VCS VERIFICATION REPORT OF THE REFORESTATION OF DEGRADED FOREST RESERVES IN GHANA

Project Title	Reforestation of degraded Forest Reserves in Ghana
Version	1.3
Report ID	VR_FORM Ghana_1.3

Report Title	VCS VERIFICATION REPORT OF THE REFORESTATION OF DEGRADED FOREST RESERVES IN GHANA
Client	CMO INTERNATIONAL

Table 9

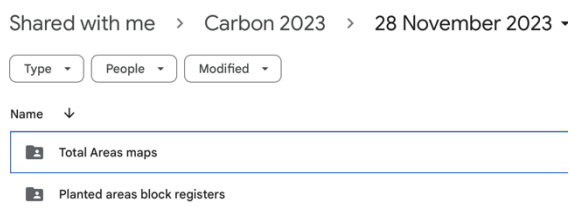
2. The version of the methodology has been unified 3. Please, explain why there is a difference between the At=73,690.9 of table 9 and the 373,400 from table 10 4. It is still incorrect. Equation (4) according to the methodology is not the equation reported in page 58 section 5.2 5. The VVB is not able to verify the correct area with the evidence provided (Blocks). Please, explain the origin of the difference, and provide new evidence with the shapefiles indicating the correct size of the areas or the differences between total area and plantation area. 6. The name of the methodology has been corrected.								
Project Proponent's Response					Date: 12/12/2023

The block registers indicating the planted areas correlate with the areas in the table below. We have updated four area figures in the Stratification table (Table 8, copied below) – these figures are all aligned with the figures in the block registers that show the planted areas. Shapefiles which account for all areas (planted and unplanted) have also been uploaded in the shared drive as indicated in point 5 below. All the calculations are now based on the updated areas.

- 3 This was a typing error. All the figures are now updated to reflect the correct totals.
